**Appendix H
(continued)**

RE: PCW's compliance with the Service's comprehensive eagle avoidance and minimization recommendations

RE: Revisions to CCSM Project Phase I Wind Turbine layout in response to the Service's eagle avoidance and minimization recommendations made on December 5, 2013

Figure 1 - Phase I Sierra Madre Turbine Layout

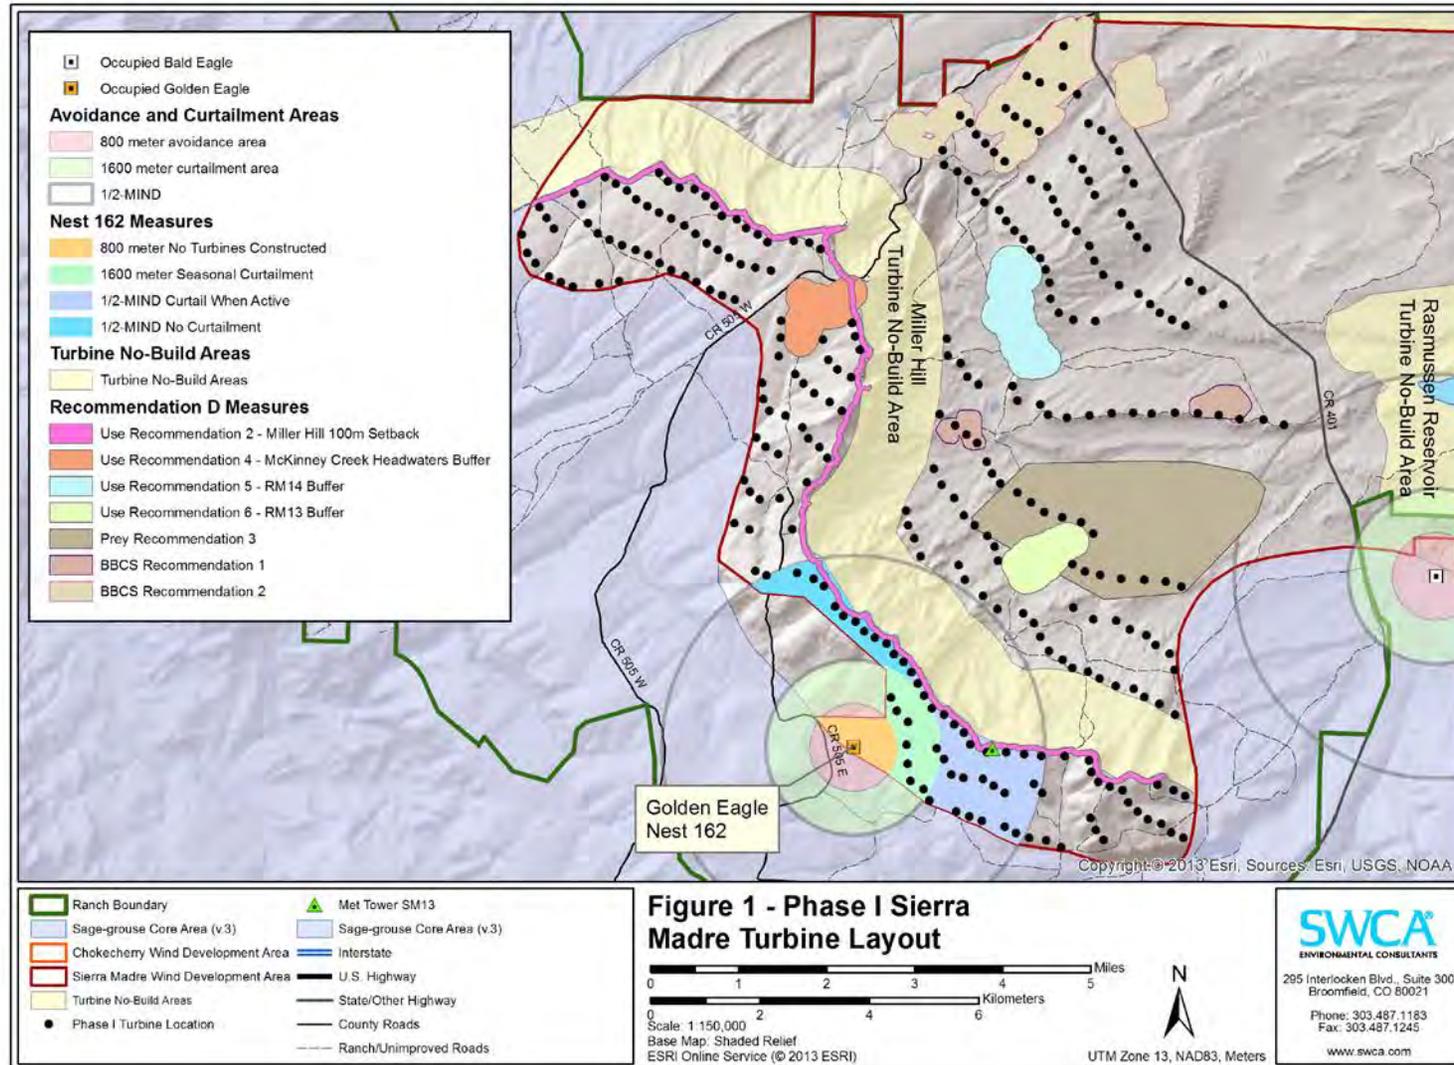
In compliance with Nest Recommendation 2, there are no turbines within 800 meters of any golden eagle nest (occupied or unoccupied) in the Phase I wind turbine layout (Figure 1 and Figure 2). In addition, PCW has removed many turbines from locations within 1,600m of golden eagle nests, e.g. 19 turbines located within 1,600 meters of the two unoccupied nests located immediately east of nest #145 were removed from the preliminary Phase I wind turbine layout (Figure 5) .

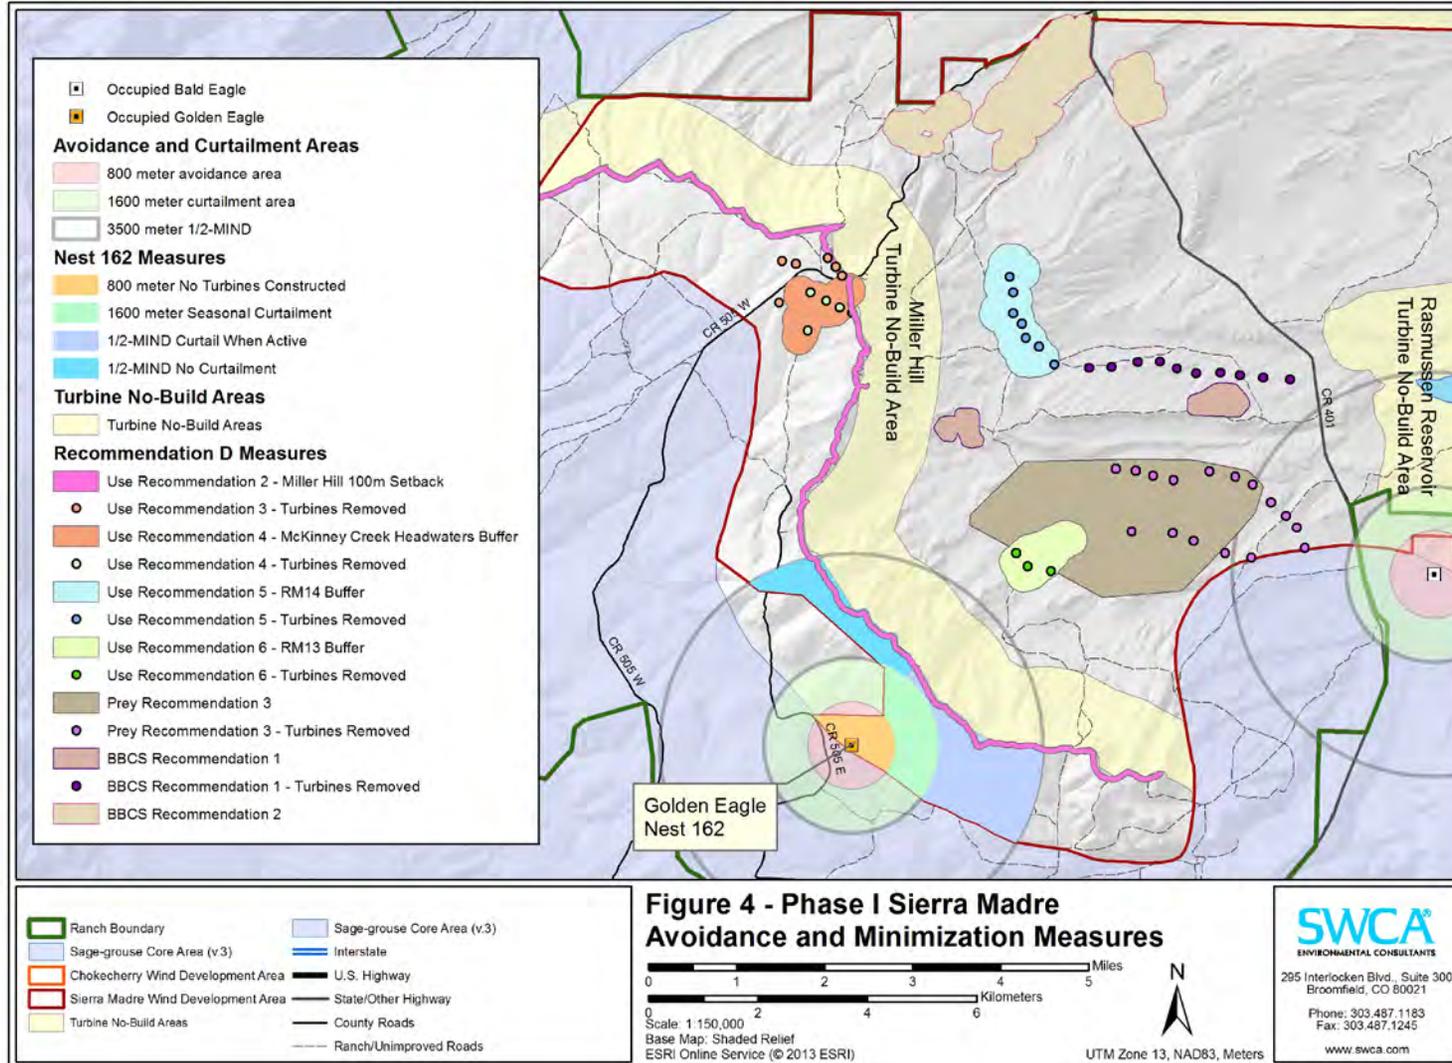
Based on this site-specific information, PCW has removed the northern turbine row and the easternmost turbines from the central row, a total of 16 turbines, from the preliminary Phase I wind turbine layout (Figure 4). This results in removal of turbines from an area of approximately 3,500 acres. The exclusion of these turbines avoids the largest concentration of the densest WTPD colonies and eagle use areas and provides a 0.5 to 1.5 mile wide corridor between the Miller Hill Turbine No-Build Area and the Rasmussen Reservoir Turbine No-Build Area and Sage-Grouse Core Areas. When combined with

Use Recommendation 2 has been applied to the Phase I wind turbine layout as shown in Figure 4. Implementing this recommendation resulted in the removal of 9 turbines from the preliminary wind turbine layout. In addition, while removing and rearranging the Phase I wind turbine layout to accommodate this recommendation, the bases of the wind turbines were generally moved farther than 100m from Miller Hill Rim; therefore this measure is consistent with Use Recommendation 2. *See attached Figure 4 – Sierra Madre Avoidance and Minimization Measures*

immediately north of County Road 505W and 1 approximately 1200m south of County Road 505W) and has set one turbine back approximately 270m from Miller Hill Rim (Figure 4). The removal and setback of these turbines avoids impacts to eagles in an area with documented use and provides the protection intended by the Service with the 300 meter setback because it removes turbines and expands the flight corridor in this area when combined with the measures adopted for Use Recommendation 4. This measure provides equal or greater protection to eagles and non-eagle raptors as it removes many of the highest risk turbines and expands the avoidance areas described in Use Recommendation 4. *See attached Figure 4 – Sierra Madre Avoidance and Minimization Measures*

Eagle flight paths in the area are roughly perpendicular with Miller Hill Rim and consist of direct powered flight indicating that eagles are using the predominant westerly and southwesterly wind directions to move through the area. Eagle use data does not indicate that eagles are using this area for soaring and kiting behaviors; however, after review of the eagle use data, PCW has removed 6 turbines from the preliminary Phase I turbine layout in this area to maintain a movement corridor for eagles (Figure 4). When combined with the measures described in PCW's response to Use Recommendation 3, the removal of these turbines creates a 0.75 to 1 mile wide movement corridor that provides a connection to undeveloped portions of Miller Hill, the Miller Hill Turbine No-Build Area, and the other avoidance areas PCW designated in response to Use Recommendations 2 through 6. *See attached Figure 4 – Sierra Madre Avoidance and Minimization Measures*

Figure 6. Summary of eagle flight minutes between August 2012 and March 2013. The Y-axis represents the number of minutes of observed eagle use recorded during each week’s survey efforts. Approximately 30 hours of survey occurred each week during this period.

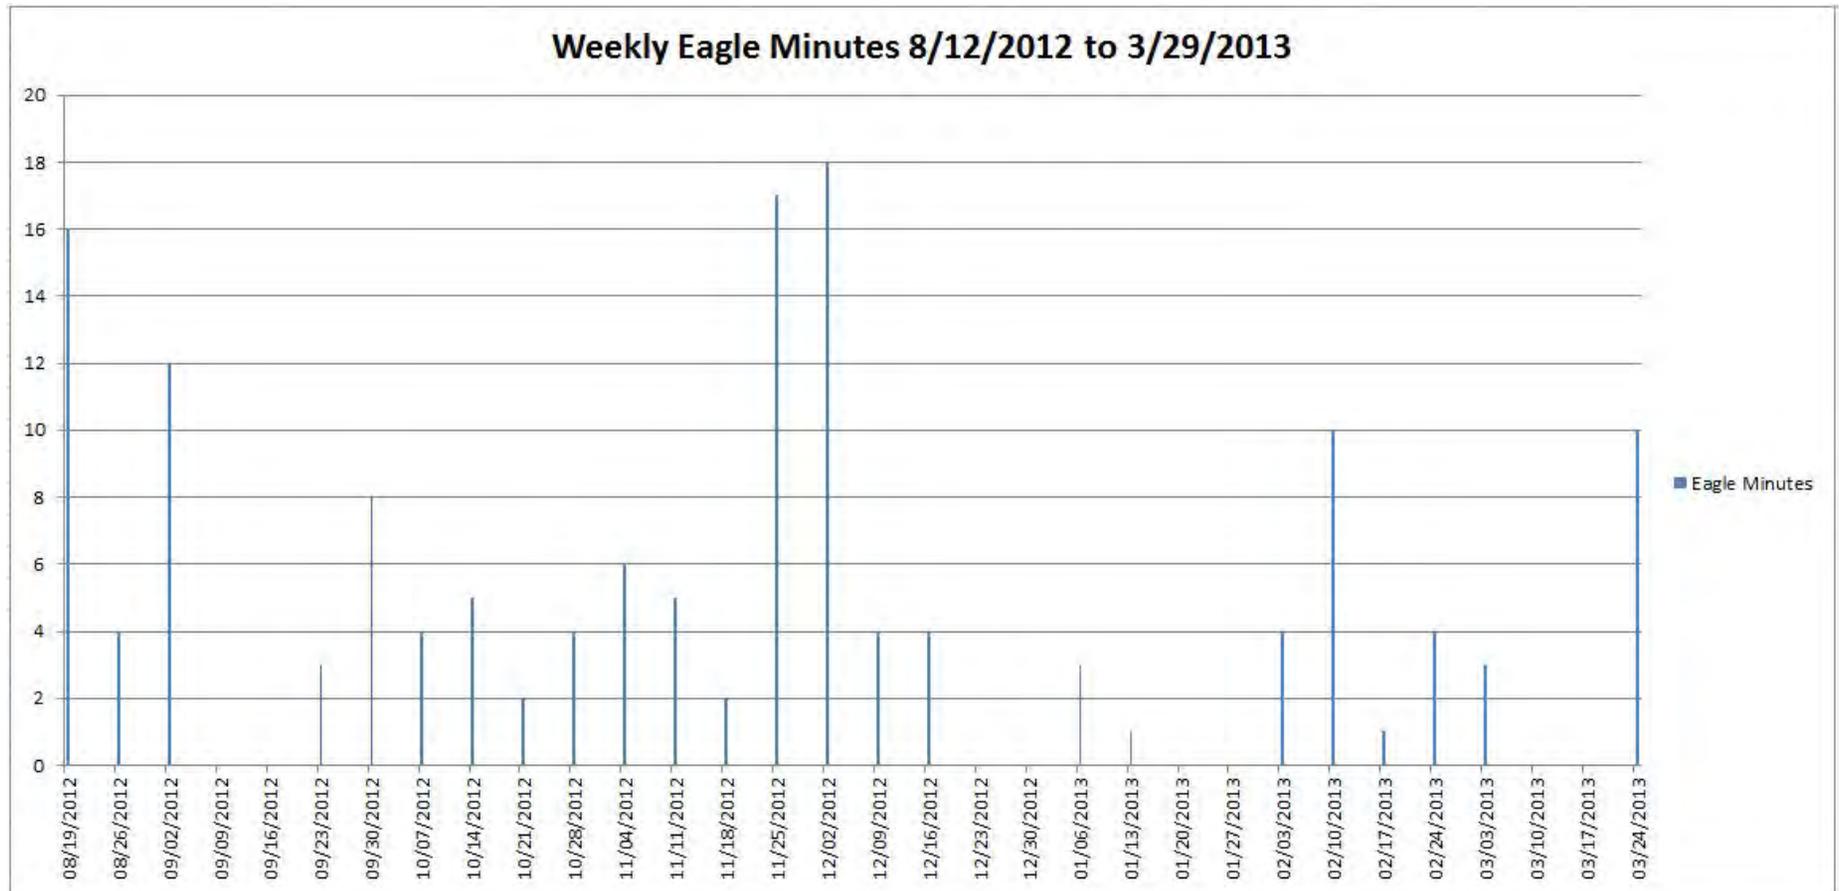
Where turbines are still located within 1,600m of a golden eagle nest, turbines will be curtailed between February 1 and April 30 or until nest activity is determined. While the Service recommended seasonal curtailment from January 15 through May 1, PCW is proposing to curtail turbines seasonally between February 1 and April 30 based on site-specific data. The attached histogram generated from 800-meter point count data

collected in 2012 and 2013 demonstrates that eagle use of the Phase I development area is very low during January and increases in mid-February (Figure 6). Because of the extremely low documented use in January, PCW proposes to begin seasonal curtailment on February 1 of each year and continue seasonal curtailment until the activity of each nest is determined.

Figure 7. Annual Wind Rose for Meteorological Tower "Sierra Madre 13"

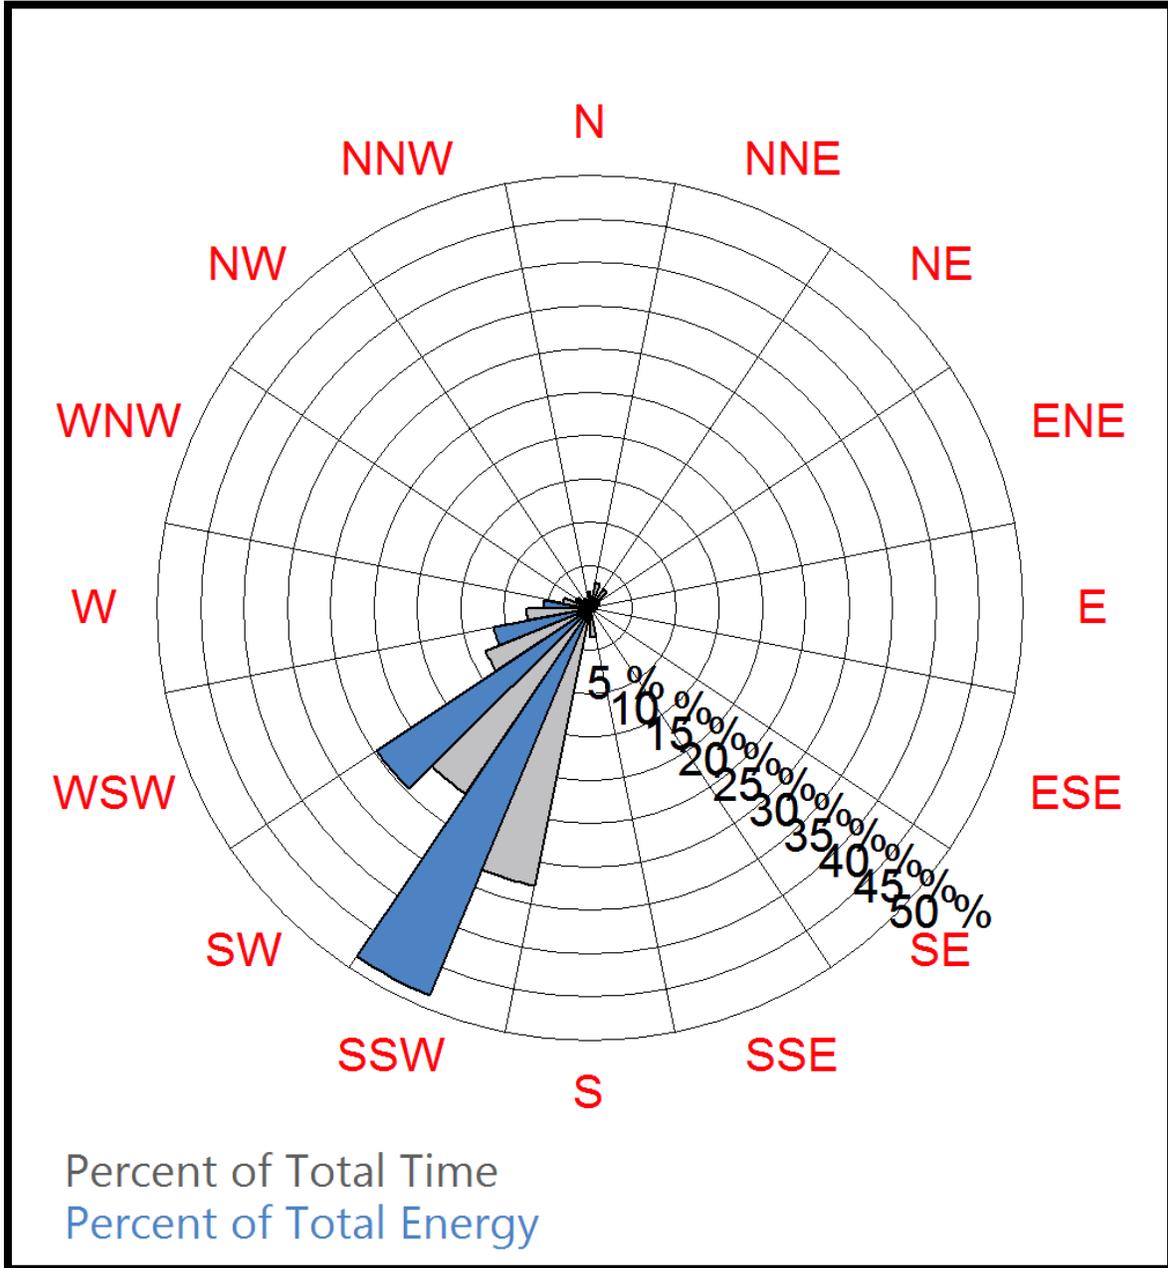
PCW's understands that this recommendation is intended to minimize risks to eagles that could use the Miller Hill Rim for soaring and kiting behaviors. PCW has collected extensive data on the wind resource on the CCSM Project Site. Winds in the CCSM Project Site are from the west and southwest for as much as 75% of the time, as demonstrated on the attached wind rose from meteorological tower Sierra Madre 13 located on Miller Hill (Figure 7).⁶ Since Miller Hill faces to the east and northeast, downdraft conditions are commonly created along the Miller Hill Rim. Because of the strong directionality of the winds in the CCSM Project Site and the predominantly downdraft conditions, Miller Hill Rim does not provide regular soaring and kiting opportunities for eagles and other raptors. However, a 100m setback does provide protection for birds that might use the Miller Hill Rim during low wind conditions or infrequently when winds are from the east and northeast.

Figure 2 - Phase I Sierra Madre Turbine Layout

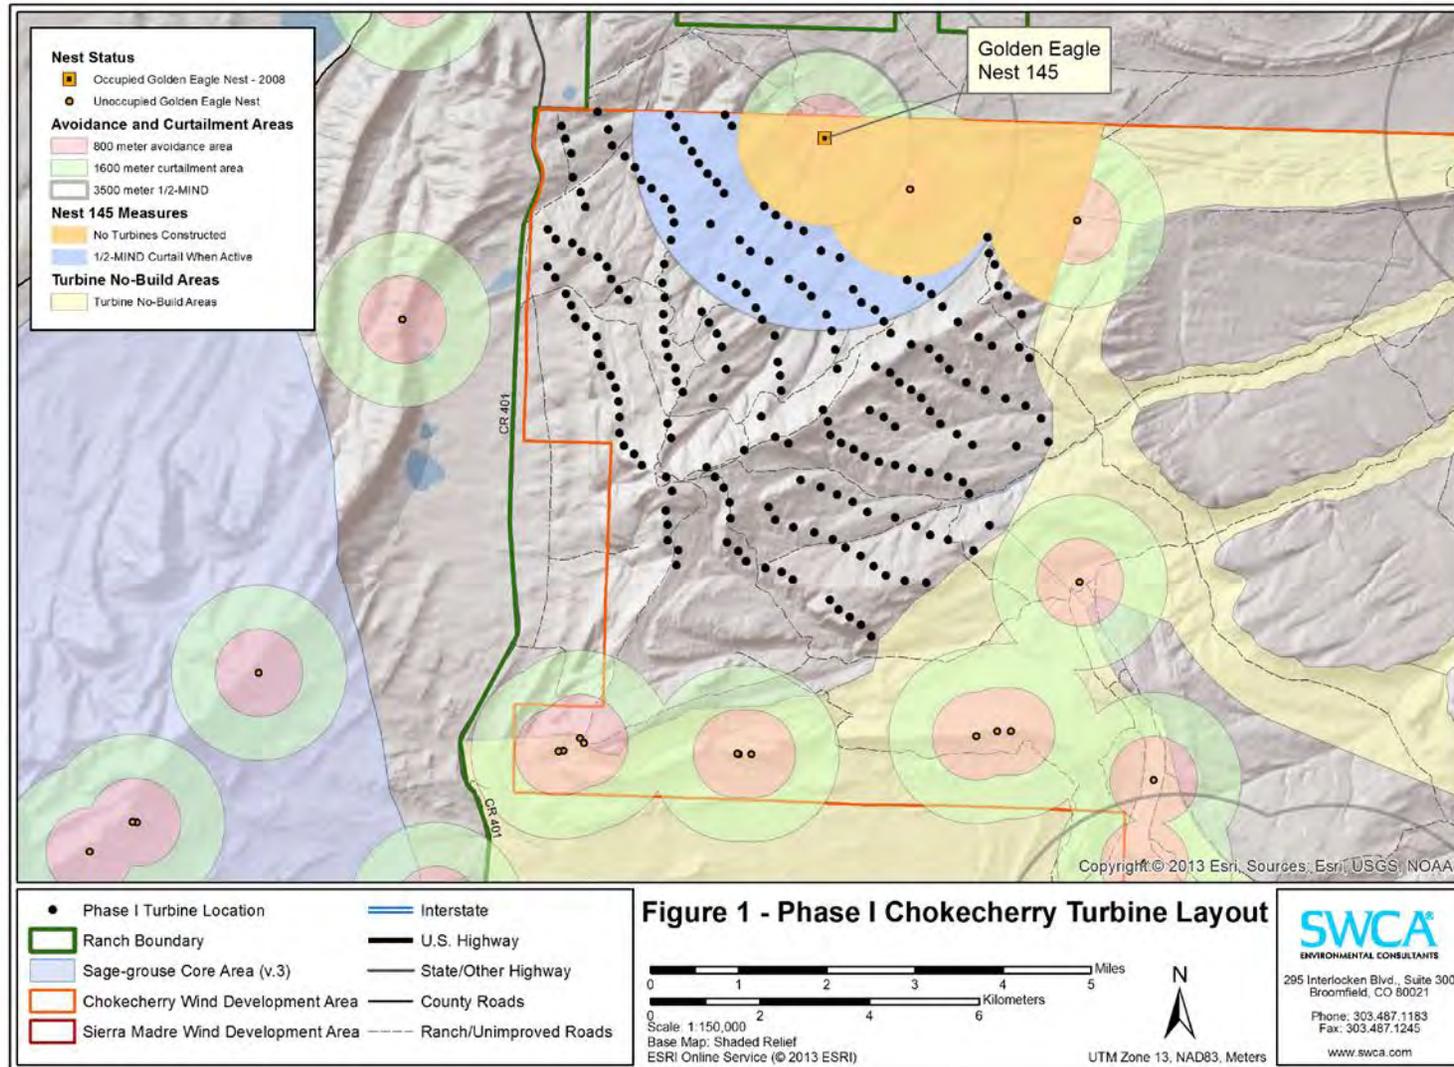
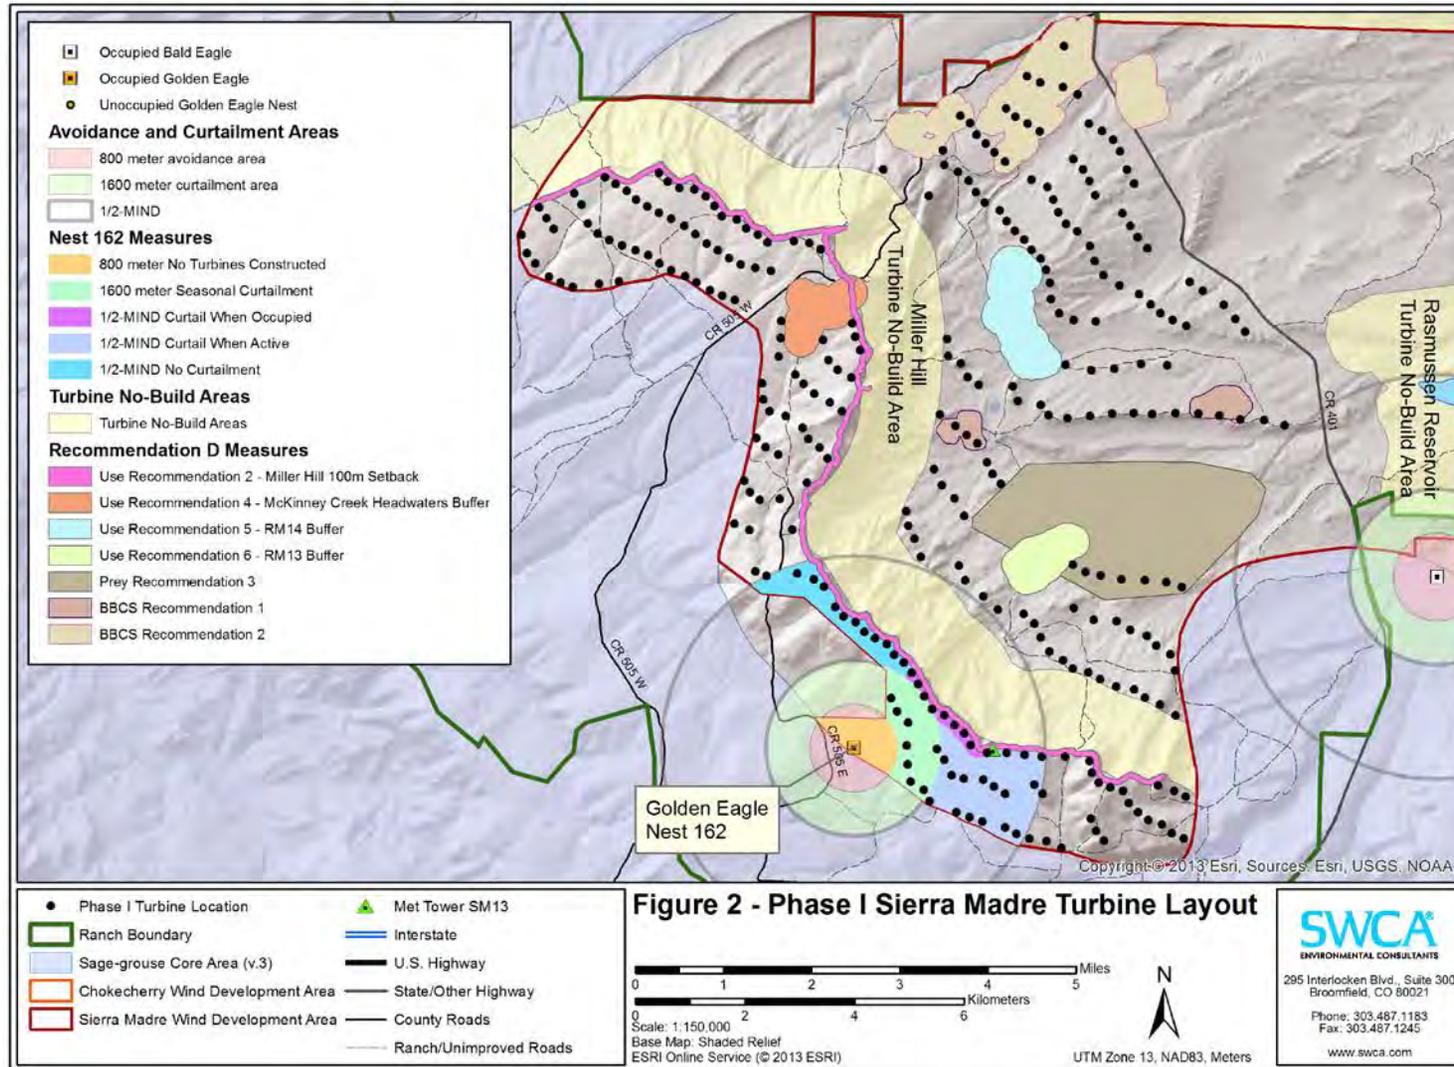
Power Company of Wyoming LLC (PCW) and the U.S Fish and Wildlife Service (Service) continue to work cooperatively to identify eagle avoidance and minimization measures for Phase I of the Chokecherry and Sierra Madre Wind Energy Project (CCSM Project). PCW and the Service met on December 5, 2013, to discuss the CCSM Project Phase I wind turbine layout submitted by PCW on November 26, 2013. This memorandum outlines the recommendations made by the Service on December 5, 2013, and provides a revised Phase I wind turbine layout that complies with these recommendations (Figures 1 and 2).

The Phase I wind turbine layout shown in Figures 1 and 2 complies with the eagle avoidance and minimization recommendations made by the Service, as set forth in the November 26, 2013, memorandum from PCW to the Service and as updated following the meeting on December 5, 2013. The layout reflects the measures recommended by the Service and implemented by PCW to avoid and minimize impacts to bald and golden eagles to the extent practicable such that that additional take is unavoidable, consistent with the ECP Guidance, Wind Energy Guidelines, and the provisions of the Bald and Golden Eagle Protection Act.
